## DEVIATION REVIEW AND DECISION FORM

Subdivision or Project Name: Claremont Commercial Subdivision Filing No 2.

Section of ECM from Which Deviation is Sought: 2.3.7.E.1 Turn Lane Design Elements

PCD File No. SP-17-004

## STREET PAVEMENT MARKING & MEADOWBROOK PKWY. SIGN PLAN

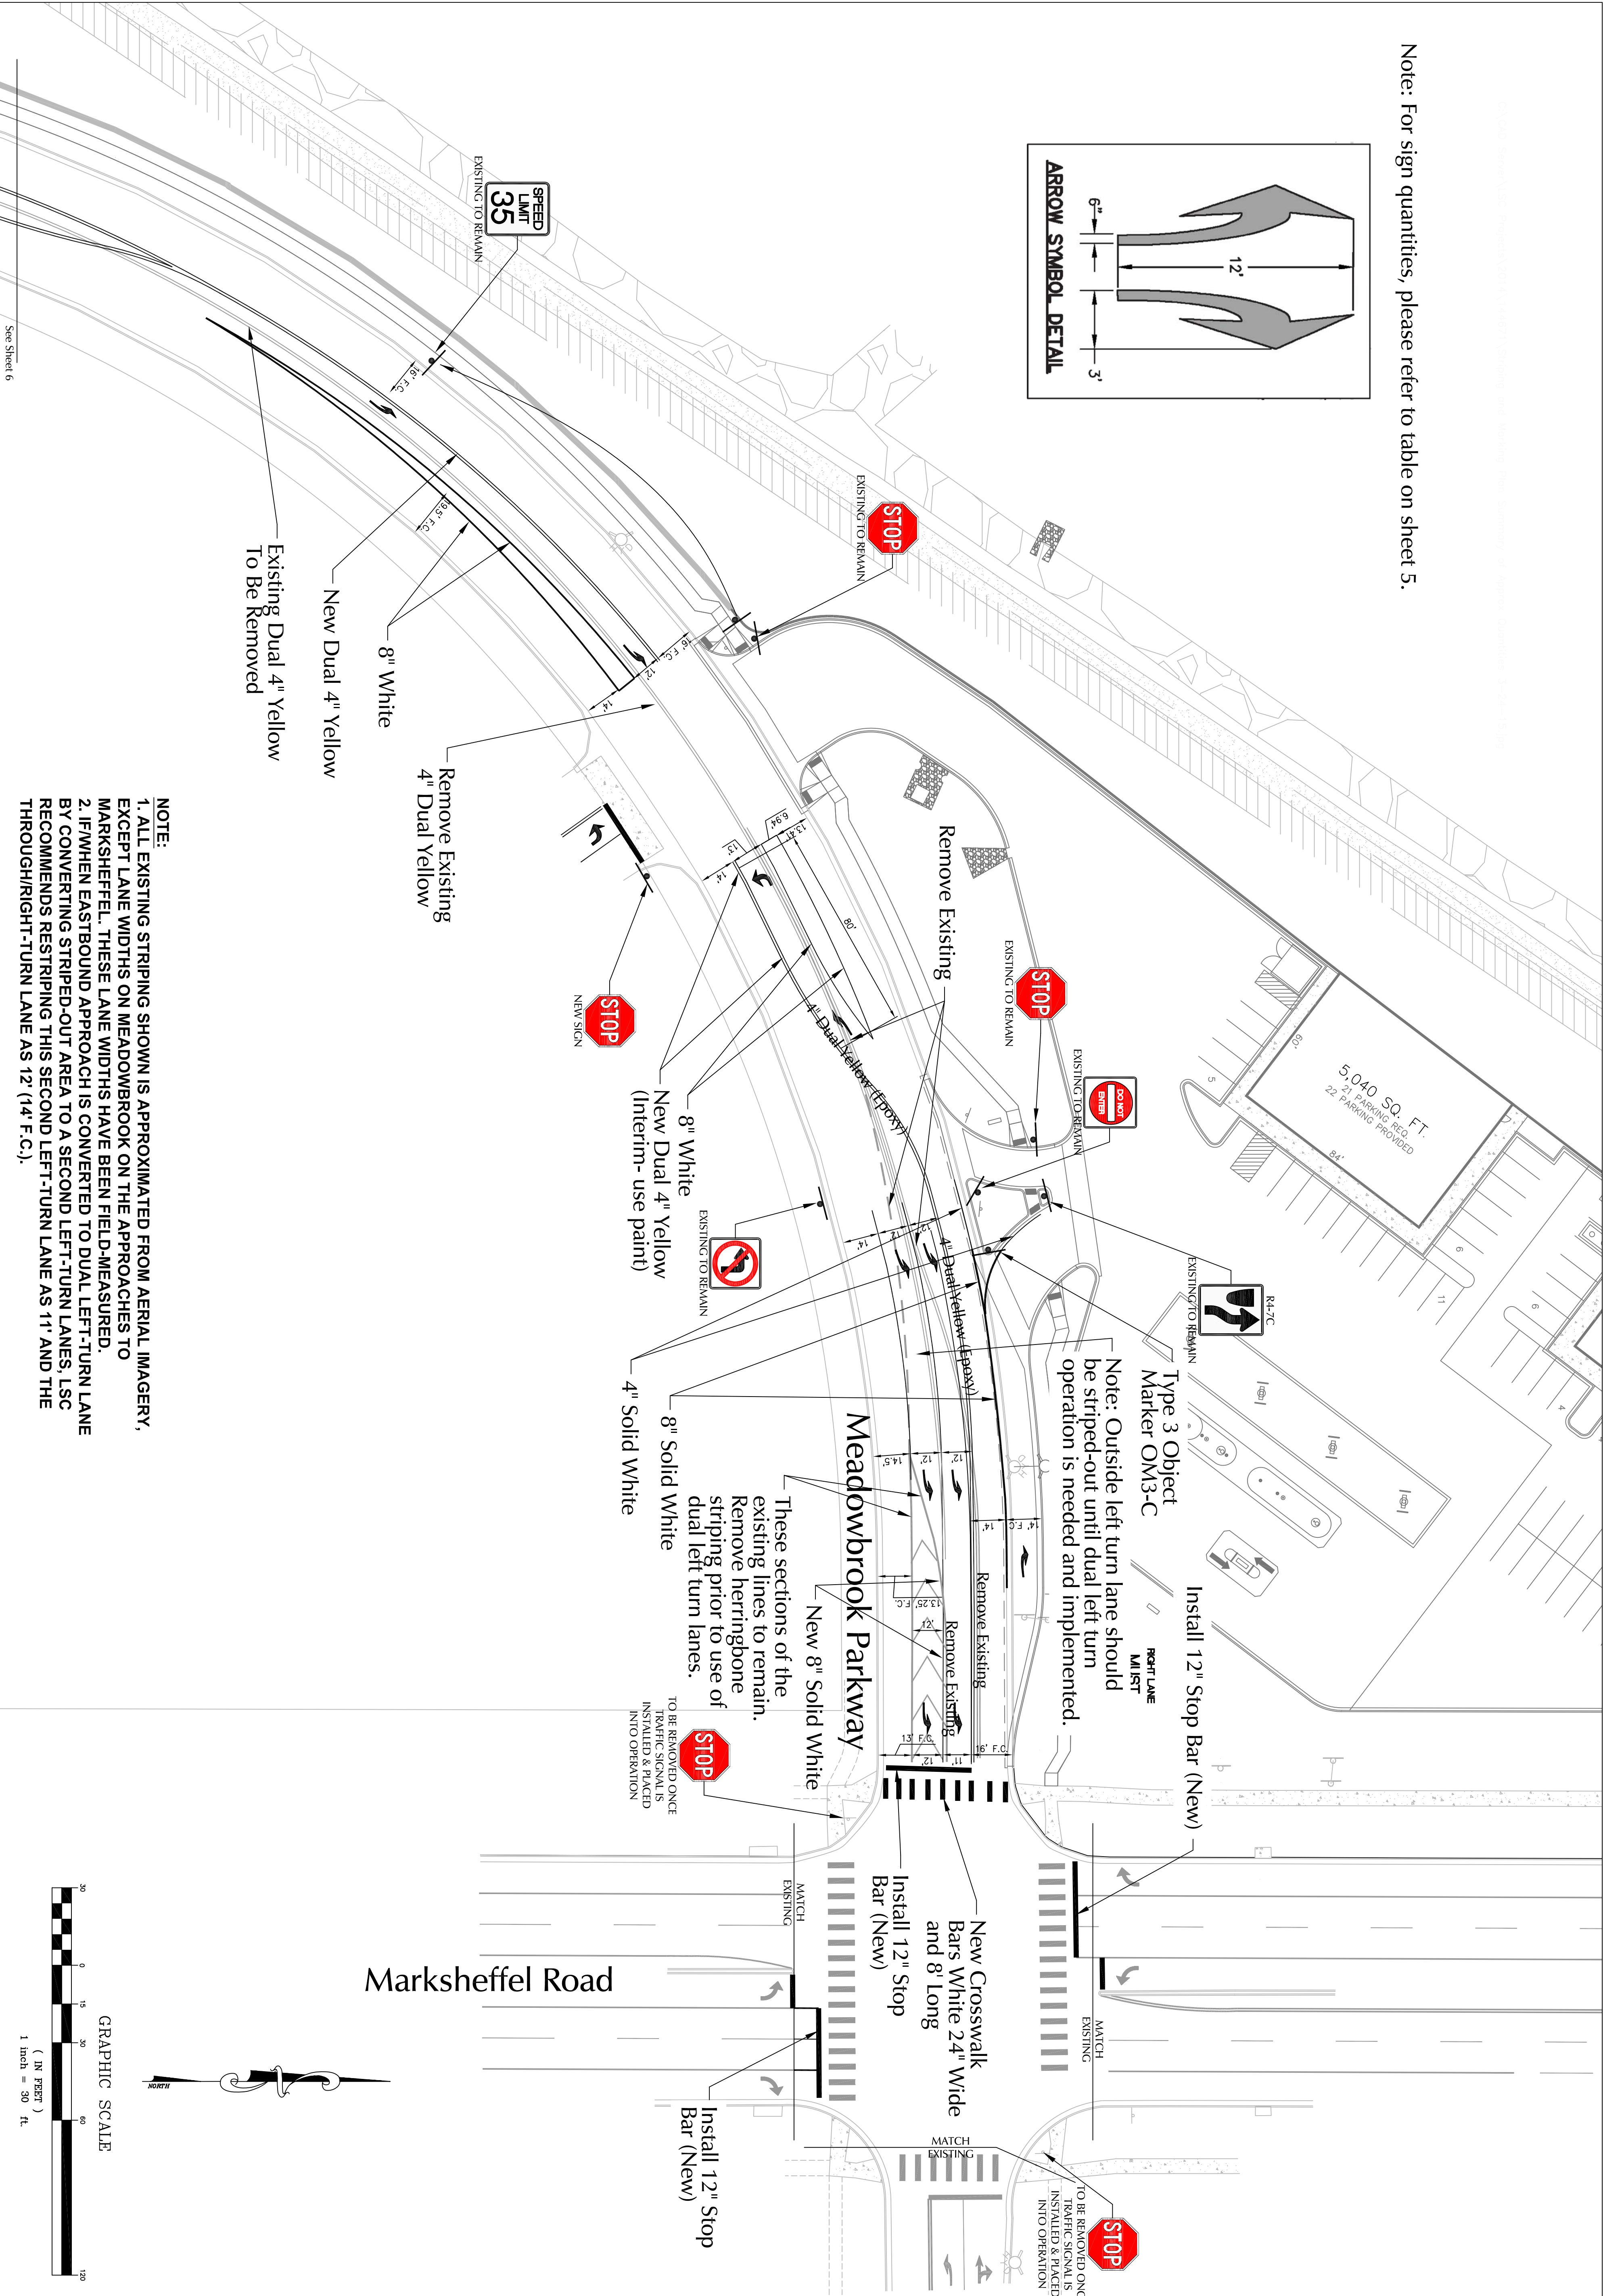
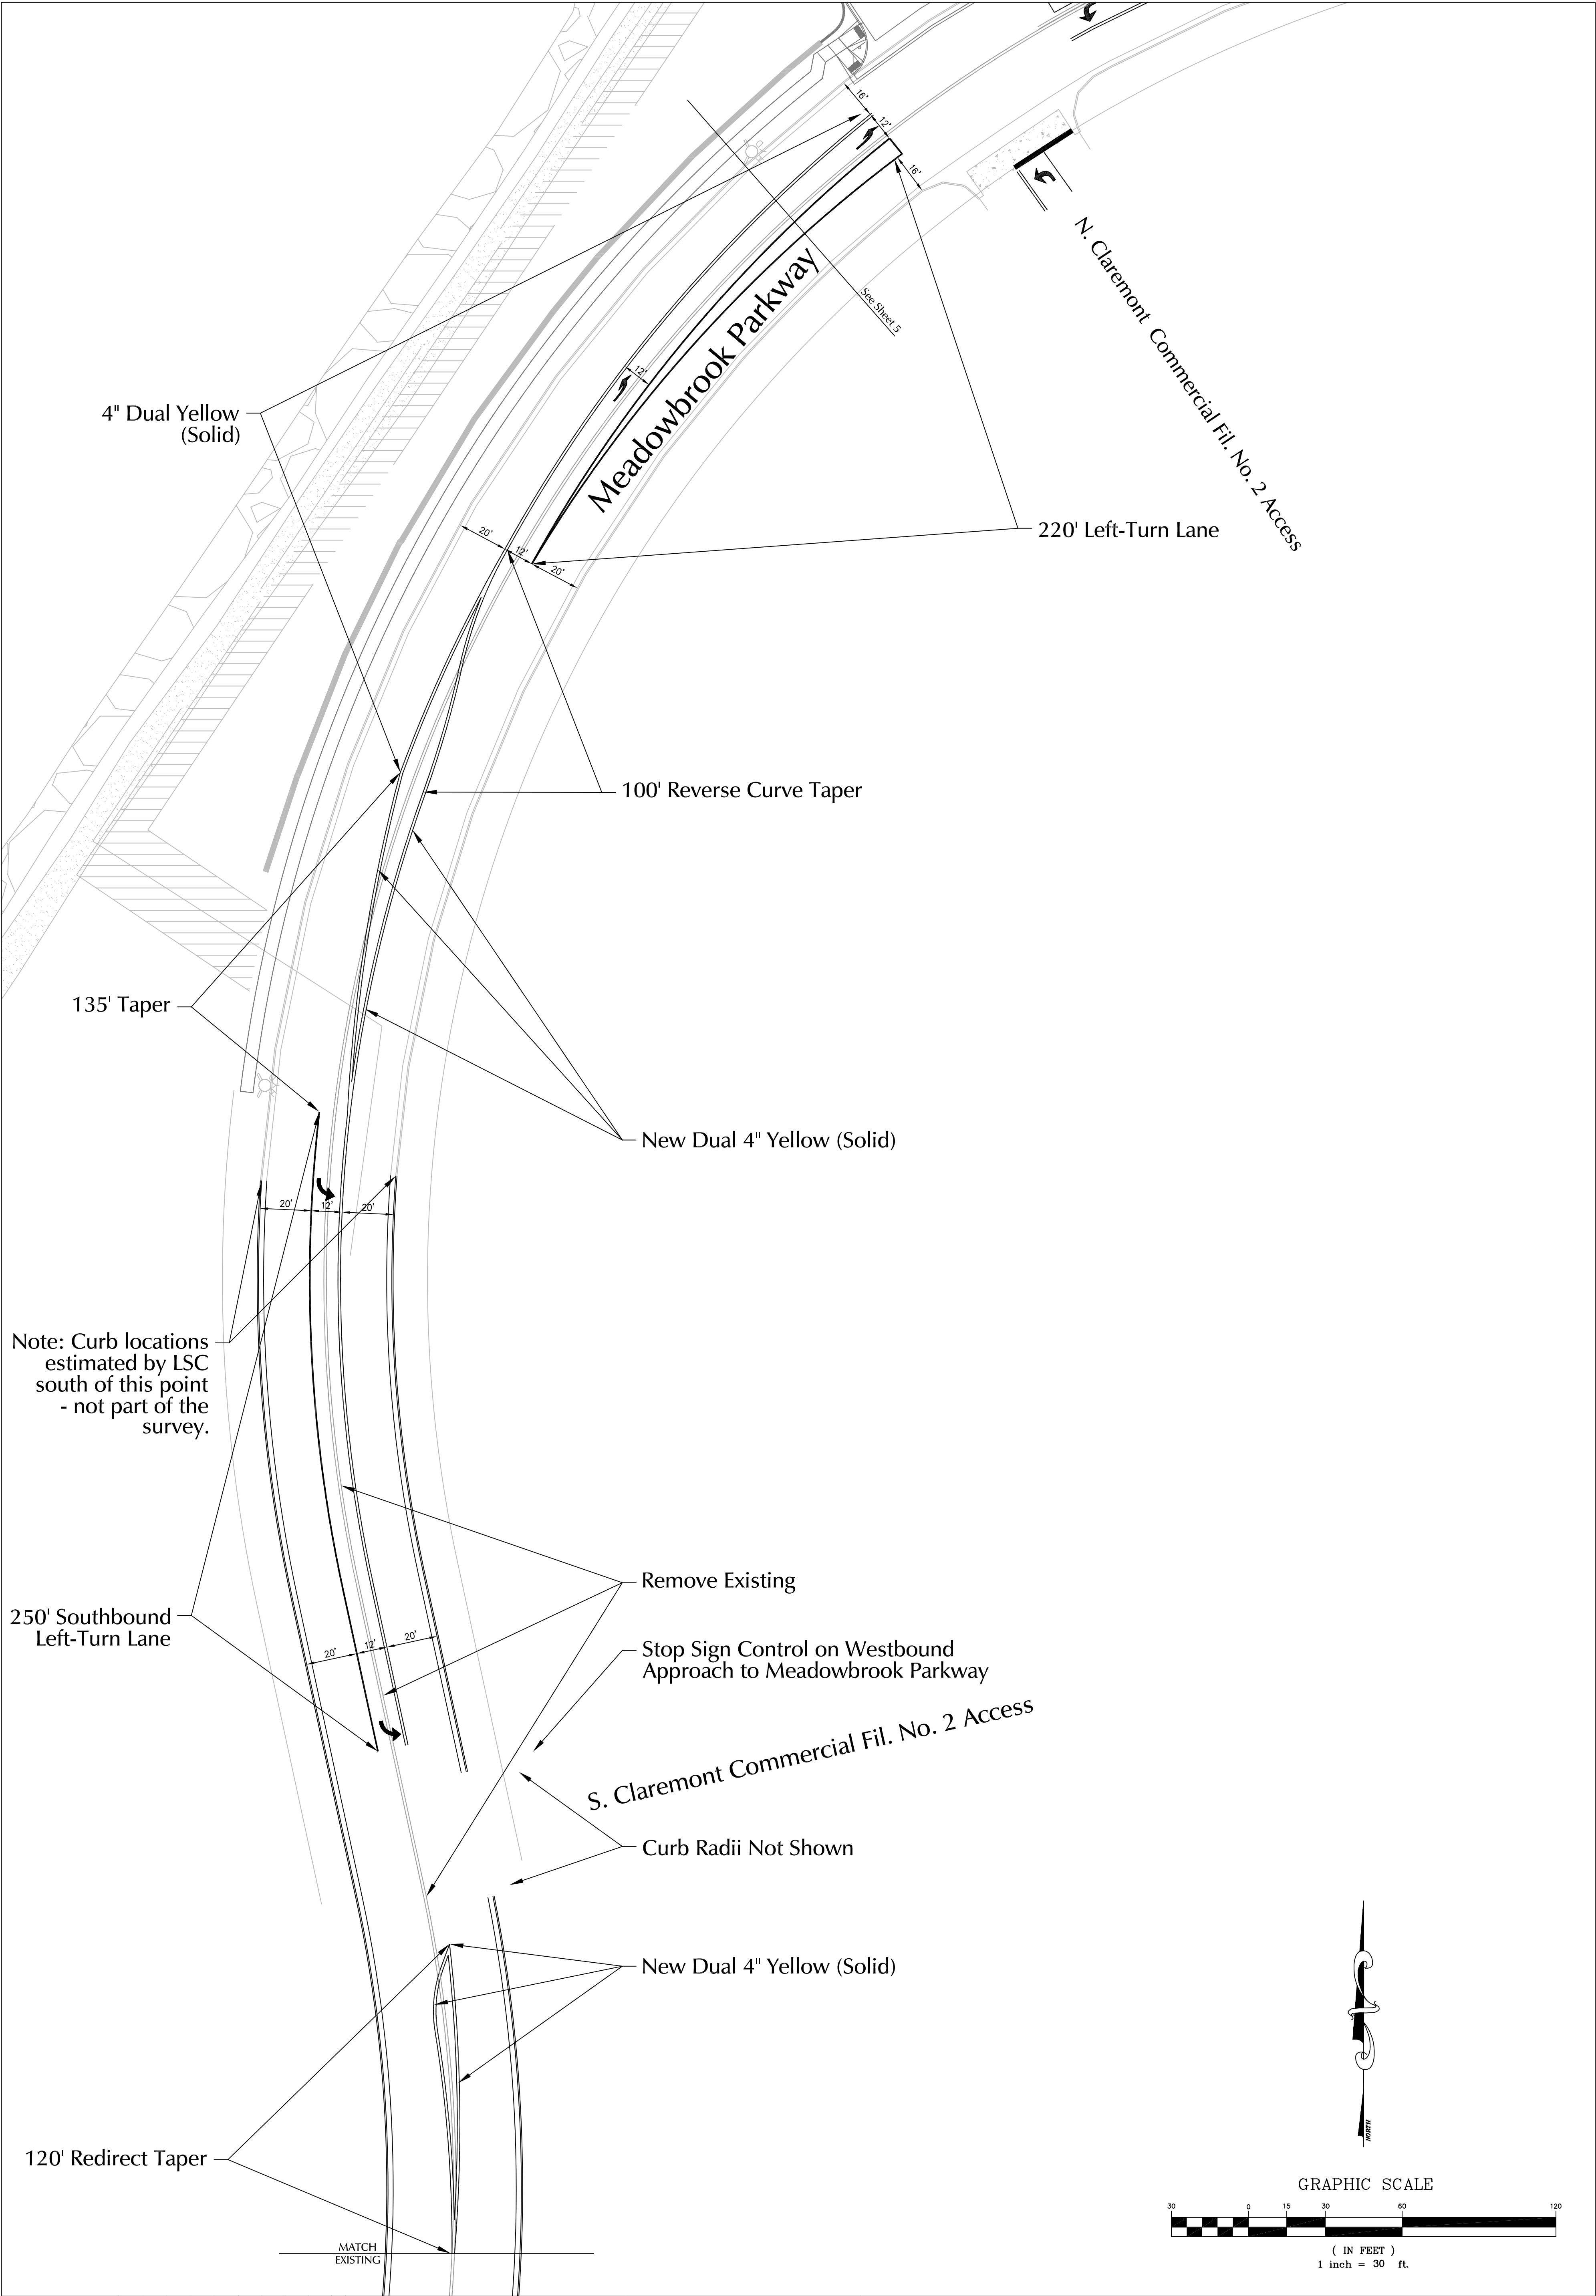
Proposed Nature and Extent of Deviation: Allow abbreviated left-turn lane lengths on Meadowbrook Parkway between Marksheffel Road and the north full-movement site access given the constrained distance (about 490 feet) between the two intersections. The ECM prescribes deceleration plus vehicle storage distance plus transition taper for left-turn lanes on collector roadways where turn lanes are required per section 2.3.7.D. The attached striping plan for Meadowbrook Parkway reflects turn bay storage and abbreviated reverse curve bay tapers between the site access and Marksheffel. The intent of the striping plan was to allocate the back-to-back left-turn stacking distance available between the intersections to the eastbound left-turn lane (future dual left-turn lanes) at Marksheffel and the westbound left-turn lane at the north site access on Meadowbrook Parkway.

Comparison of Proposed Deviation to ECM Standard: The ECM standard for a 35-mph posted speed limit is 155 feet of full-width lane plus a 160 taper plus storage distance. These lengths apply to both the eastbound left turn at the Marksheffel intersection and the westbound/southwest-bound left-turn lane approaching the site access points of Meadowbrook Parkway. Regarding storage distance, ECM Table 2-30 calls for 100 feet of storage for the Stop-Controlled intersections; however, the westbound left turn is at a Stop-sign-controlled intersection, but it is not a Stop-sign-controlled approach rather a left turn from the major street. Eighty-five feet of storage is proposed for this left-turn lane. The dual left storage distance for the eastbound dual left-turn lanes at the Marksheffel/Meadowbrook intersection based on Figure 2-27 is about 275 to 300 feet minimum. The striping shows about 225-foot dual left-turn lanes. The taper shown is about 100 feet.

The proposed left-turn lane and taper dimensions shown on the striping plan will provide the optimal balance for the back-to-back left-turn lanes along Meadowbrook Parkway between Marksheffel and the north site access given the spacing constraint. Please refer to the queuing analysis in the traffic report.

The traffic report presents a queuing analysis for the left-turn lane lengths depicted in the striping and signing plan. The queuing analysis indicates during one fifteen-minute interval during the afternoon peak hour the eastbound through/right lane blocked entry to the adjacent eastbound left-turn lanes about 25 percent of the time and backed to the site access intersection about two percent of the time. The
